CITY of NOVI CITY COUNCIL

Agenda Item 1
December 19, 2016

SUBJECT: Approval of the request of GR Meadowbrook, LLC for approval of a Concept Plan, Preliminary Site Plan, Phasing Plan, Stormwater Management Plan, and Special Development Option (SDO) Agreement for the Huntley Manor site, JSP16-34. The property is located on the south side of Grand River Avenue, west of Meadowbrook Road in the Gateway East (GE) District and consists of a 203-unit multiple-family gated community.

SHEET 3

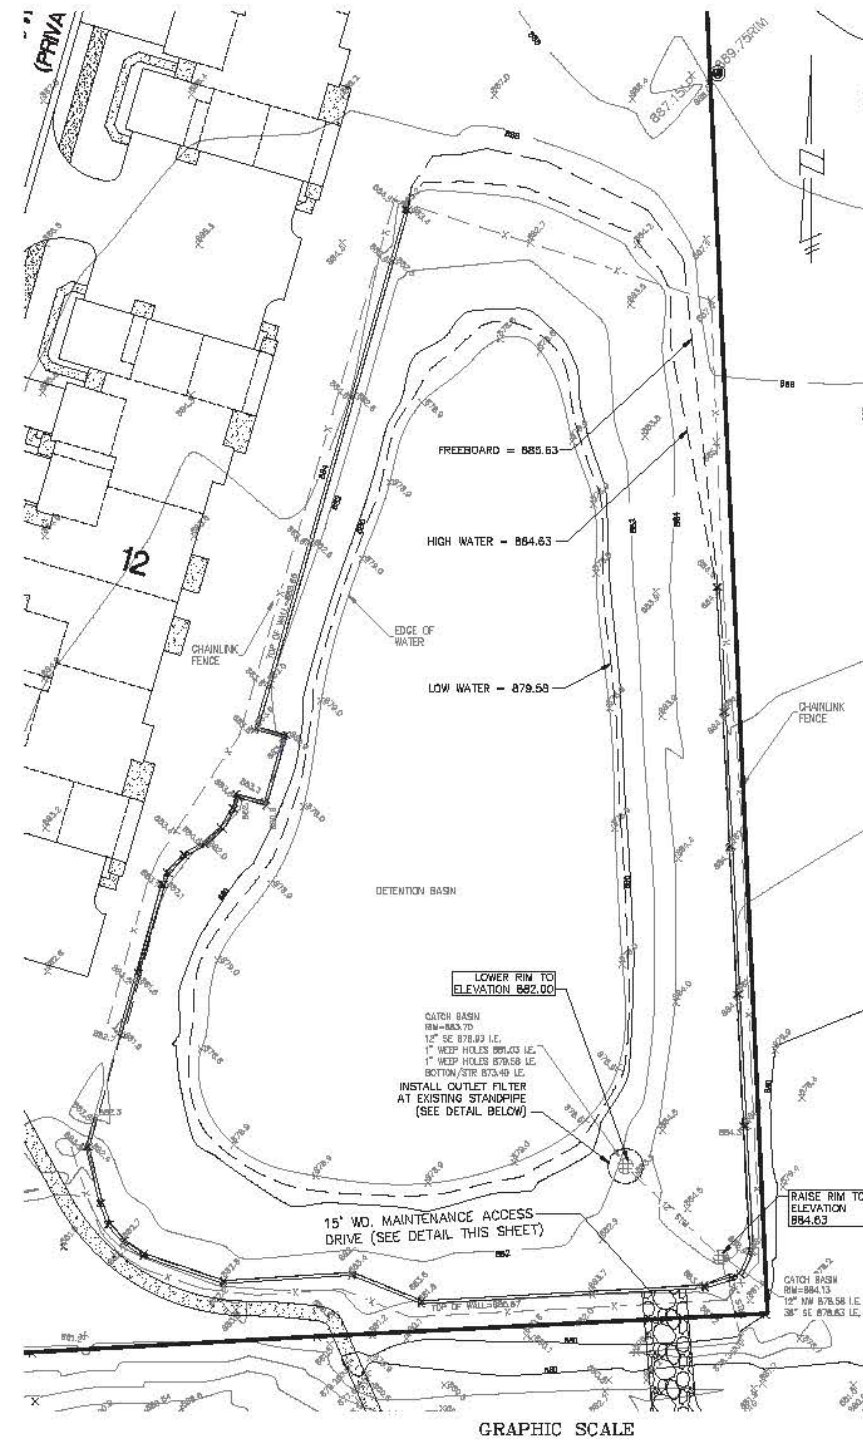
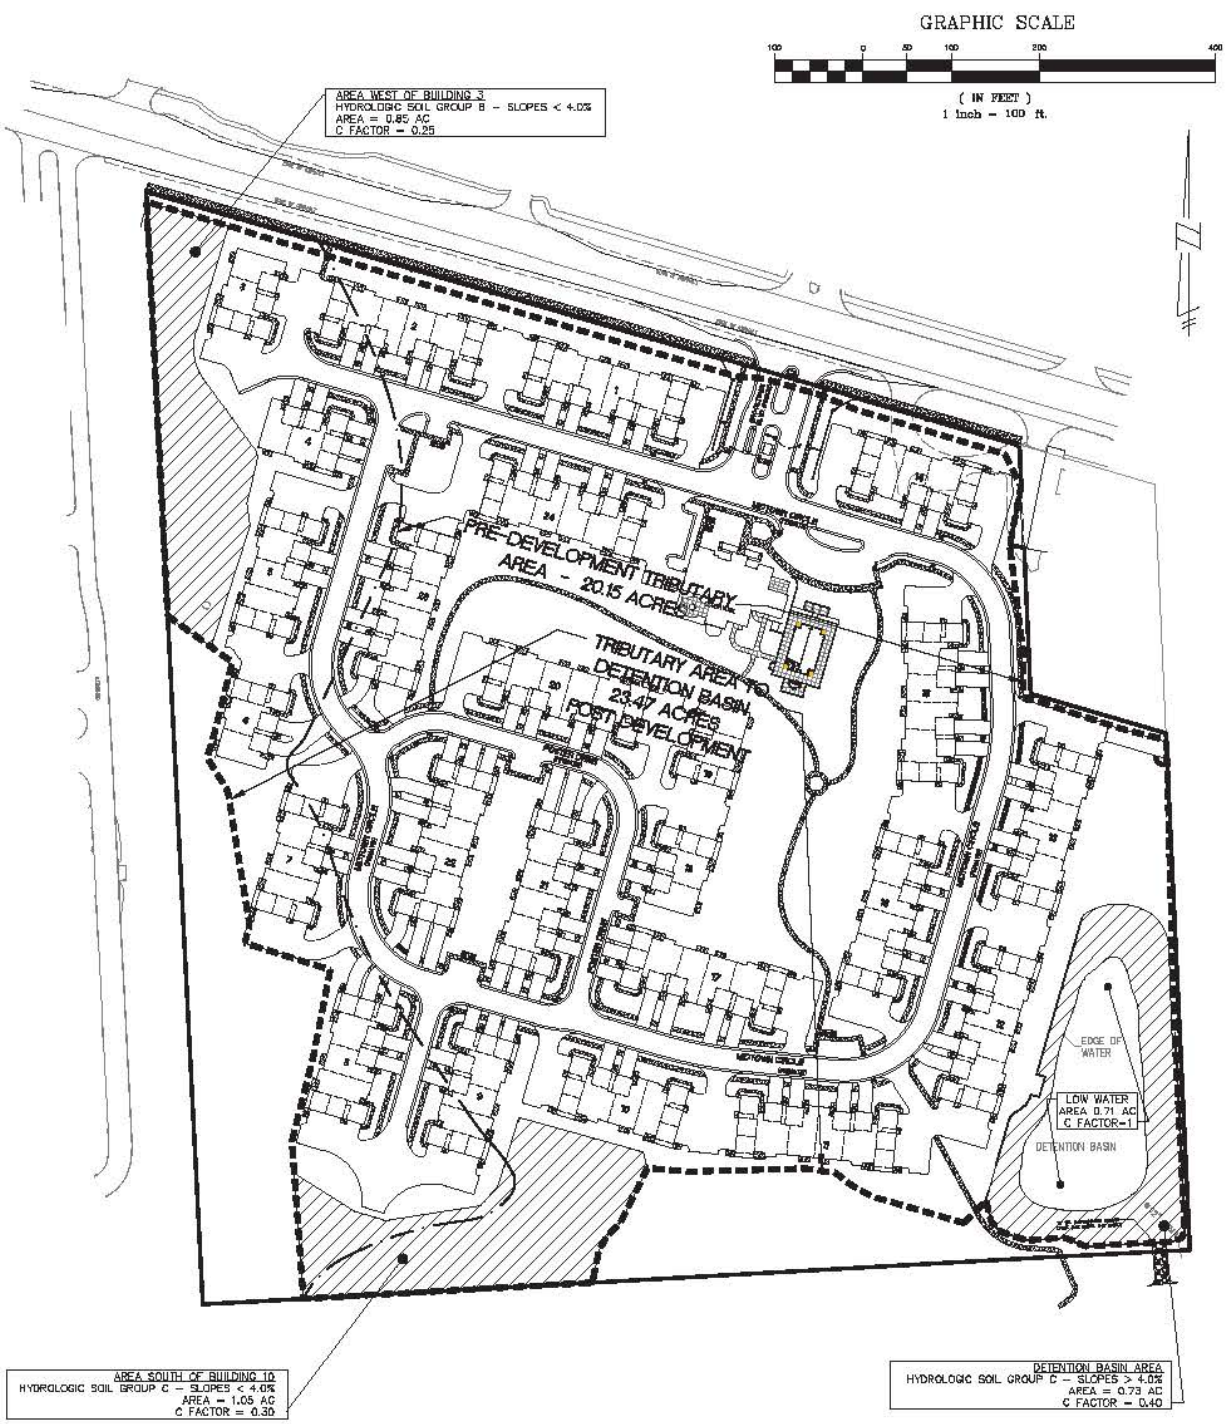
ECT has reviewed the City of Novi Official Woodlands Map and completed an onsite Woodland Evaluation on October 29, 2014. An existing tree list has been included with the Plan. Sheet 3 (*Preliminary Site Plan – South Portion*) contains a list of existing on-site trees that are proposed for removal. This sheet also indicates the location of the Regulated Woodland Boundary as shown on the City of Novi Regulated Woodland Map (see Figure 1).

The Plan (Sheet 3) indicates the proposed removal of fourteen (14) trees. None of these trees proposed for removal are located within the area mapped as regulated woodland on the City of Novi Regulated Woodlands Map. Although the proposed site development will cover the majority of the site, the majority of the site has been previously cleared for development.

SHEET 4

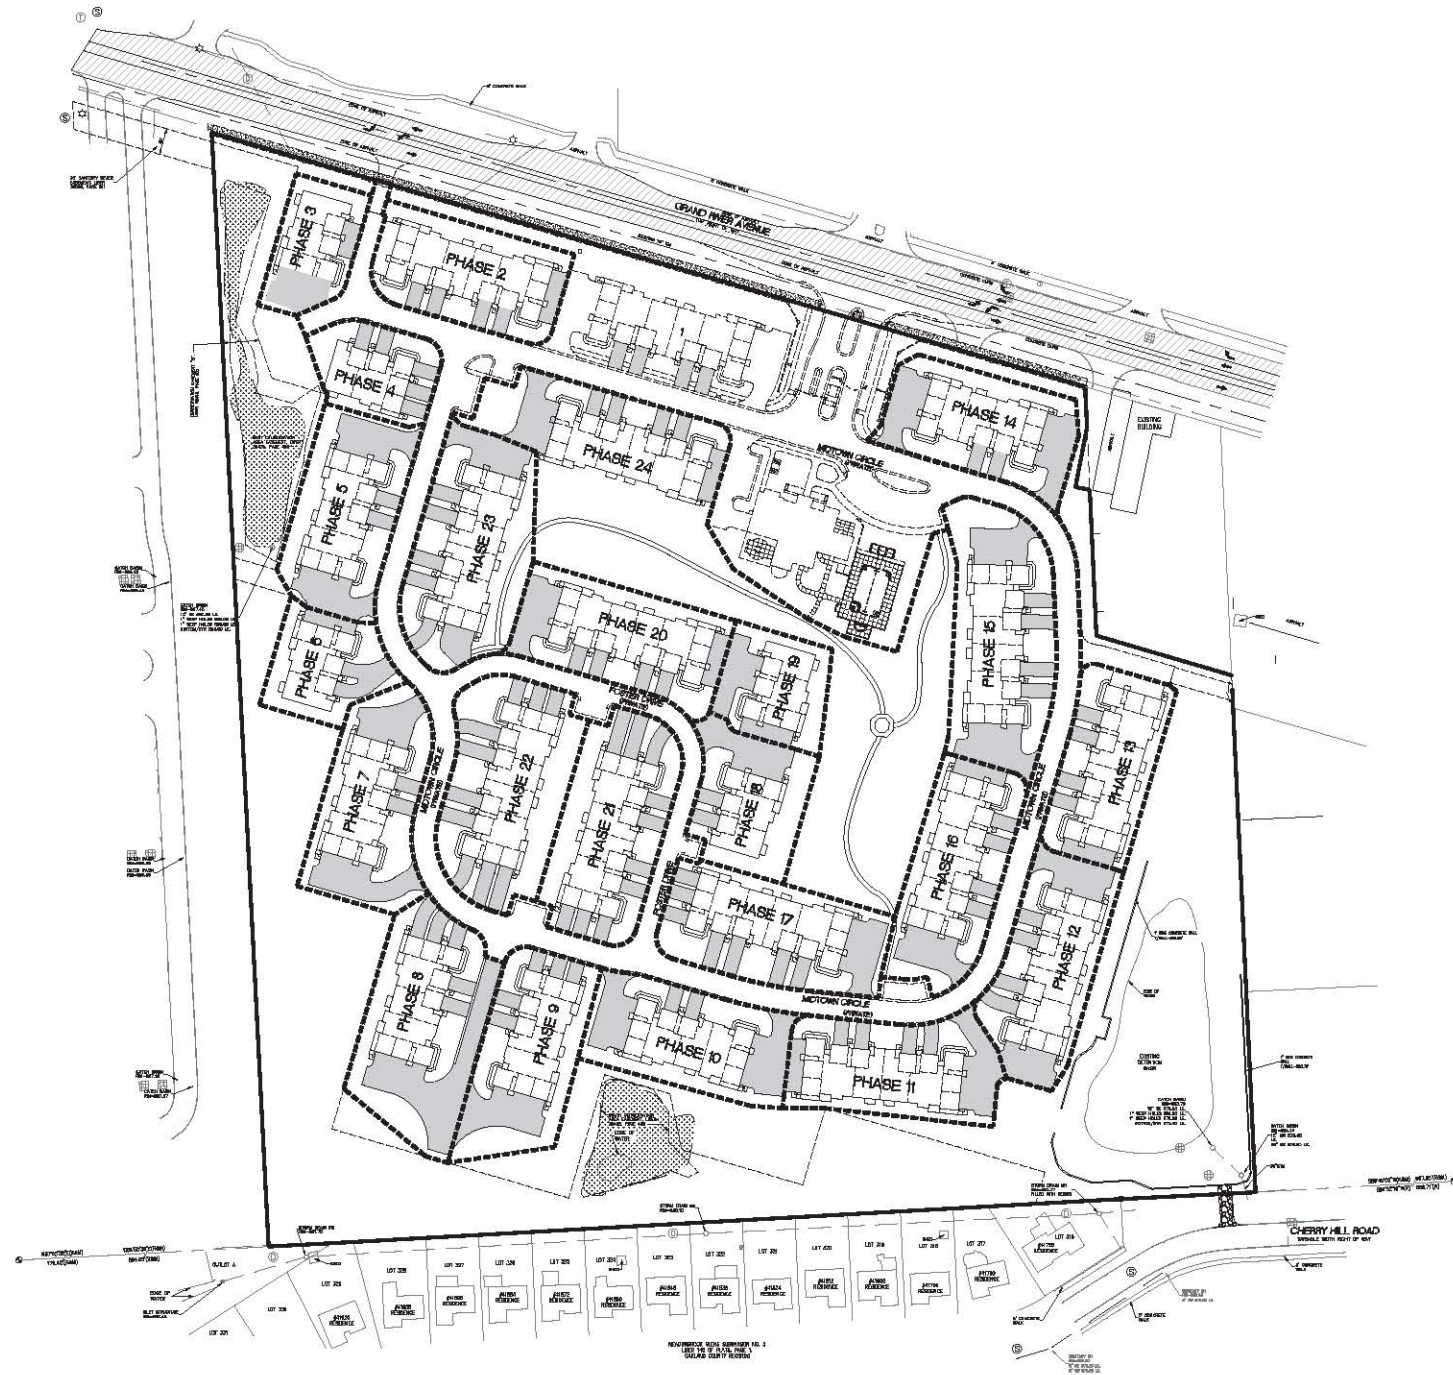
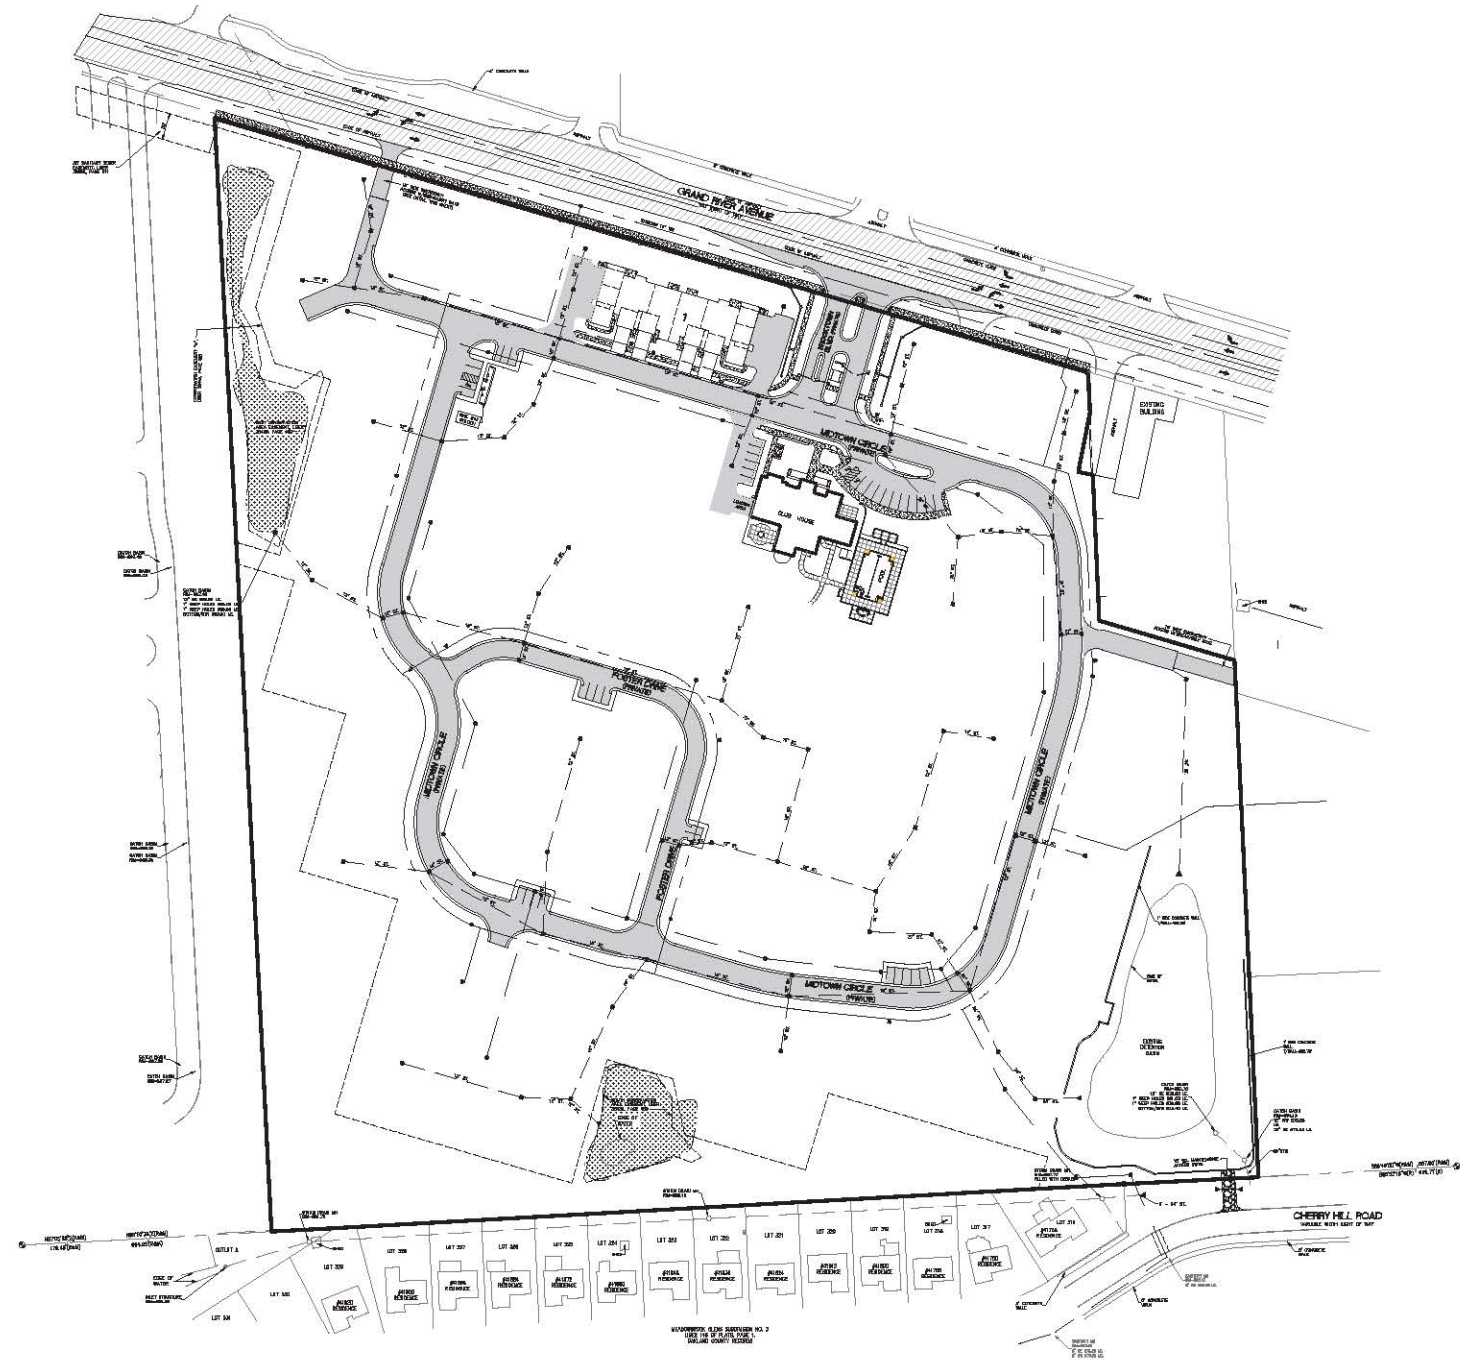
A total of 24 phases are provided during project development – one phase for each building. Phase 1 includes all the roadways and infrastructure for the entire development including the clubhouse and pool, and Building 1. Each phase thereafter includes one building and related driveways and landscaping. See Sheet 5 of the plan set for phasing details.

SHEET 5

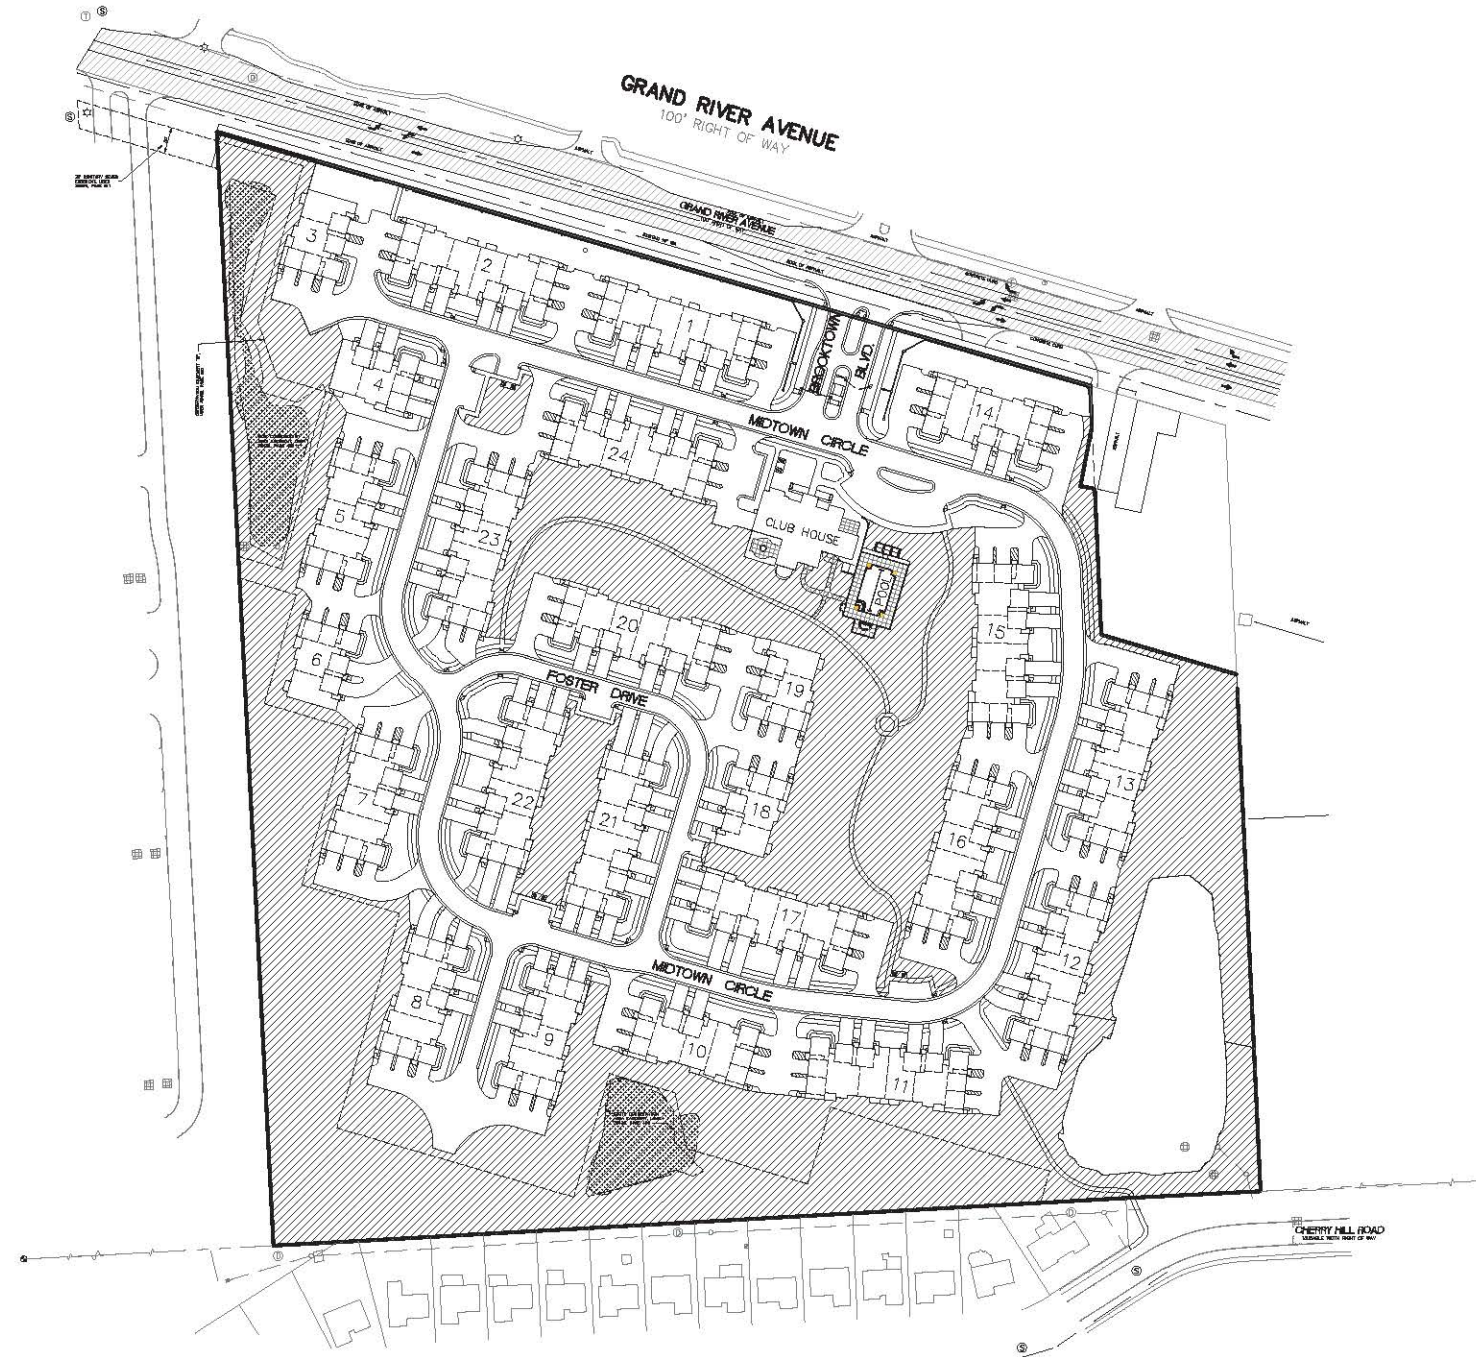
Of the 26.62 acres of land within the site, 9.98 acres will be open space, providing an open space ratio of 37.5 percent. This number greatly exceeds the ordinance requirement of 25 percent. Such open space includes conservation areas consisting of woodlands, wetlands, and non-conservation lawn areas with walkways. Except for Buildings 1, 2 and 14 located on the Grand River Avenue frontage, the remaining 21 buildings either back or side to open space areas (see sheet 6 of the plan set).
